BLUE BIRD SUBDIVISION

APPLICATION NUMBER 9 DATE January 5, 2012
APPLICANT Blue Bird Subdivision
REQUEST Subdivision

DETAIL SITE PLAN

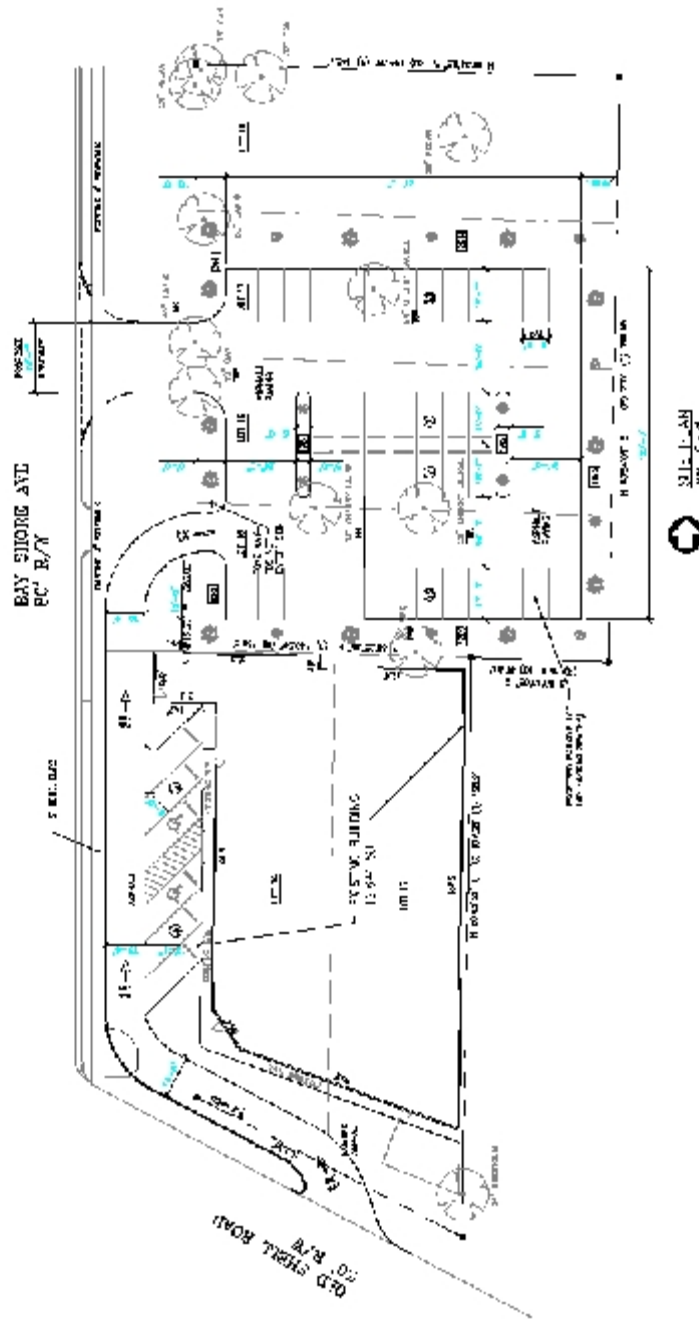
Traffic Engineering Comments: Traffic Engineering met with the engineer for the development and reviewed the proposed site plan. An ingress only driveway from Old Shell Road has been proposed in lieu of the direct access to the parking spaces adjacent to the building on Bay Shore Avenue. Exiting traffic will be directed separate from the roadway to the back parking lot, which has a two-way driveway. This configuration is acceptable. Driveway number, size, location, and design to be approved by Traffic Engineering and conform to AASHTO standards.

The site is partially developed with a 12,641 square foot building. The applicant proposes to develop a parking lot to the North of the existing building. Access to the new parking area will be via a proposed curb-cut onto Old Shell Road, and a proposed curb-cut onto Bay Shore Avenue.

Even though Old Shell Road and Bay Shore Avenue are minor streets, access management is a concern. The proposed lot should be limited to one curb-cut onto Bay Shore Avenue and one curb-cut onto Old Shell Road: any other existing curb-cuts should be removed and replaced with a city standard sidewalk, curbing and landscaping. The size, design and location of new curb-cuts must be approved by Traffic Engineering, and comply with AASHTO standards.

Based upon the preceding, the application is recommended for Tentative Approval, subject to the following conditions:

- 1) Removal of any portion of the existing structure that extends into the right-of-way of Bay Shore Avenue, or approval of a Right-of-Way Use Agreement by the City of Mobile;

- 2) Placement of a note on the final plat stating that the lot is limited to one curb-cut onto Bay Shore Avenue and one curb-cut to Old Shell Road, with the size, design and location to be approved by Traffic Engineering and comply with AASHTO standards;

- 3) Removal and landscaping of all other curb-cuts, and provision of a City standard sidewalk;
- 4) Compliance with Traffic Engineering comments (*Traffic Engineering met with the engineer for the development and reviewed the proposed site plan. An ingress only driveway from Old Shell Road has been proposed in lieu of the direct access to the parking spaces adjacent to the building on Bay Shore Avenue. Exiting traffic will be directed separate from the roadway to the back parking lot, which has a two-way driveway. This configuration is acceptable. Driveway number, size, location, and design to be approved by Traffic Engineering and conform to AASHTO standards.*);

- 5) Compliance with Engineering comments (*1.) Any work performed in the existing ROW (right-of-way) will require a ROW permit from the City of Mobile Engineering Department (208-6070) and must comply with all City of Mobile ROW code and ordinances. The plans shall include construction of a sidewalk along the Old Shell Road frontage and repair of any damaged existing sidewalk panels along Bay Shore Avenue. 2.) A complete set of construction plans for the site work (including any grading, drainage, paving, utility lines, or stormwater detention systems) will be required to be submitted with the Land Disturbance permit. These plans are to be submitted and approved prior to beginning any of the construction work. The plans shall include adequate detail(s) for removing existing driveway/curb cuts and replacing it with new curbing.*);

- 6) Depiction of the 25-foot minimum building setback line; and
- 7) Placement of a note on the plat stating that approval of all applicable Federal, state and local agencies is required for endangered, threatened or otherwise protected species, prior to the issuance of any permits or land disturbance activities.
